**BELLEVILLE COMBINED LICENSE APPLICATION – RESPONSE TO REQUEST FOR  
ADDITIONAL INFORMATION – GROUNDWATER**

Reference: Letter from Joseph Sebrosky (NRC) to Andrea L. Sterdis (TVA), Request for  
Additional Information Letter No. 062 Related to SRP Section 02.04.12 for the  
Belleville Units 3 and 4 Combined License Application, dated July 3, 2008

Subject: Groundwater as discussed in the Final Safety Analysis Report

**Figure RAI-636-1**  
**Hydraulic Potential for Groundwater Flow**  
**Between River Valleys**

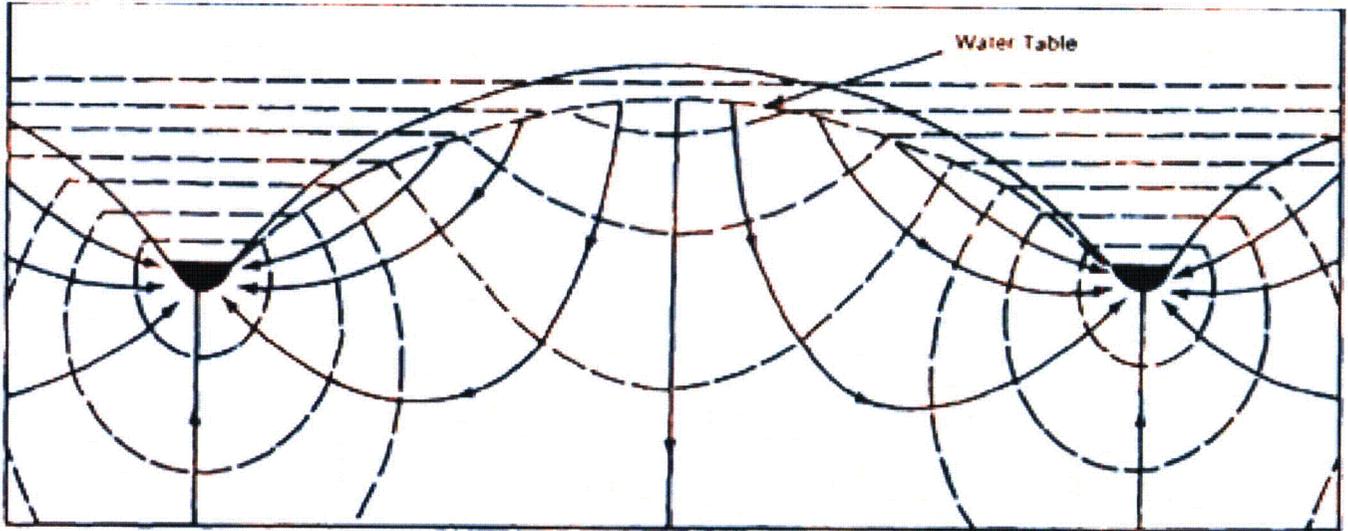
Given the potential karst development of the Knox Group and the Stones River Group, provide the technical basis for the assumption that these formations are hydraulically isolated from each other in the area of Town Creek. This issue is associated with Attachment 5, item 8, of the May 13 -16, 2008, hydrology-related safety site trip report dated June 12, 2008 (ADAMS accession number ML081610308).

Groundwater flow in river valleys will normally follow the surface topography prior to discharging to the adjacent river. Although the BLN site is located within a poorly developed, essentially fractured rock, subsurface groundwater system, the groundwater hydraulic characteristics behave similar to a granular groundwater system (Reference 1; Attachment 02.04.12-02A) in that flow within the fracture systems will follow basic hydraulic head principles, modified by being constrained to the fracture flow pathways. Water table groundwater flow in both systems will tend to flow toward the river (or perpendicular to equal contours of surface topography) with discharge to the river (Figure RAI-636-1; Attachment 02.04.12-02C) (Reference 2; Attachment 02.04.12-02B).

**Figure RAI-637-1**  
**Groundwater Potentiometric Surface**  
**Response to Rising Water Levels in Nearby Creeks**

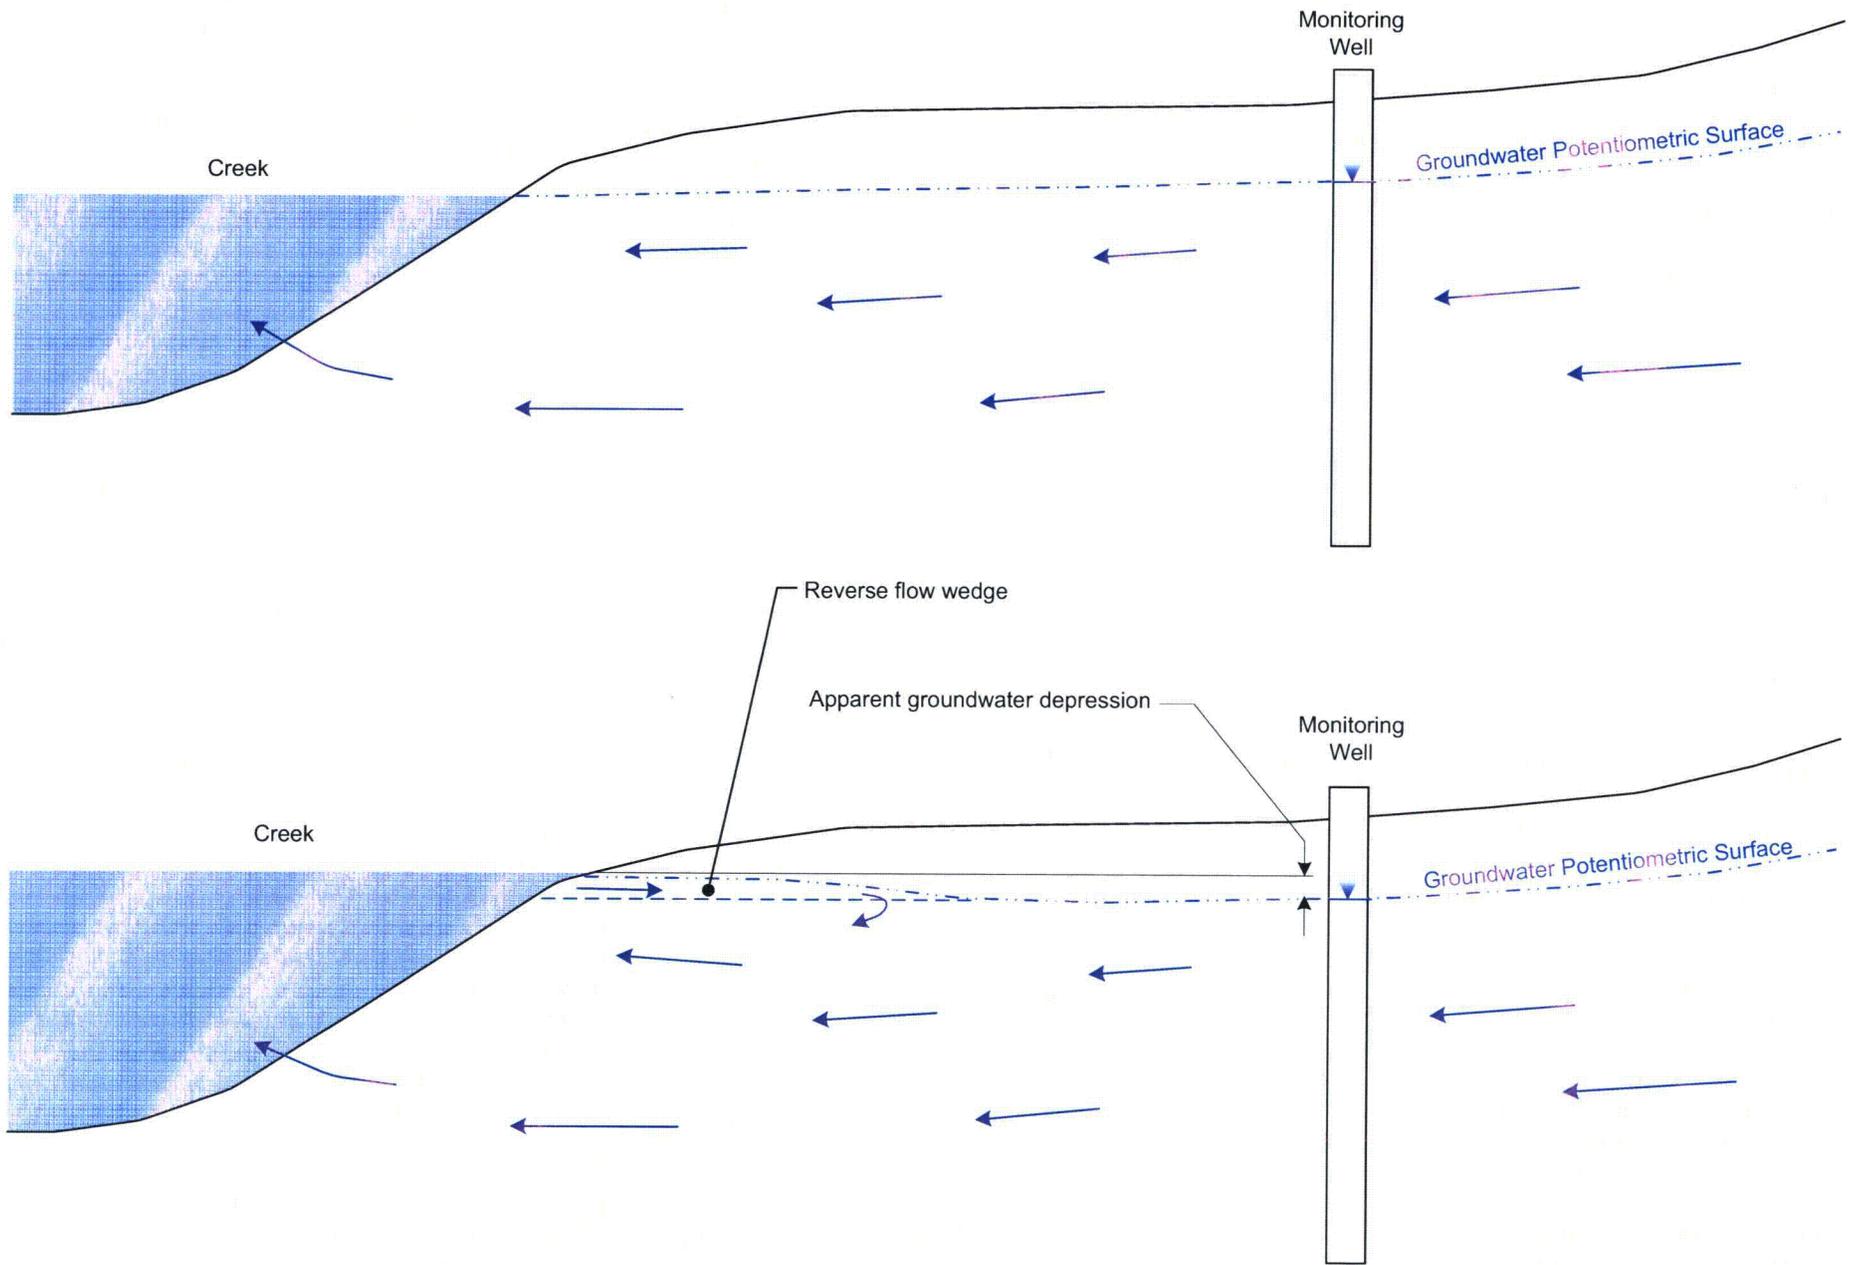
This interpretation of the groundwater head observations indicates downward movement of groundwater at MW-1212. Discuss why and how such downward movement of groundwater may occur.

This statement from the FSAR implies that the downward movement of groundwater (drainage into the lower bedrock zone) occurs only during relatively dry periods. Provide the technical basis for this conclusion. If the implication was not intended, provide a discussion of the relevance of the downward movement of groundwater at this location to subsurface pathways.

Please provide any other plausible explanations for the groundwater depression.

An additional plausible explanation of the groundwater depression is a rise in reservoir level during the monitoring time period. If the river or creek stage (level) rises, with no additional precipitation input to the adjoining land, then surface water will begin recharging the groundwater aquifer along the shores of the river or creek, setting up a reverse groundwater flow (Reference 1, page 6). If the subsurface surrounding the river or creek has a high permeability (sand, gravel, etc.), this reverse flow equalizes rapidly to form a new, stable phreatic surface; however, if the subsurface is of low permeability, the equalization time may be very long, resulting in a much slower recharge and stabilization of the aquifer phreatic surface. If an adjacent monitoring well, located within this zone of influence, is gauged prior to equalization of groundwater levels to the new river stage, then the groundwater level in the monitoring well will be lower than the current river stage for that day, thus showing an apparent "depression" of the groundwater potentiometric surface at that monitoring well (Figure RAI-637-1).
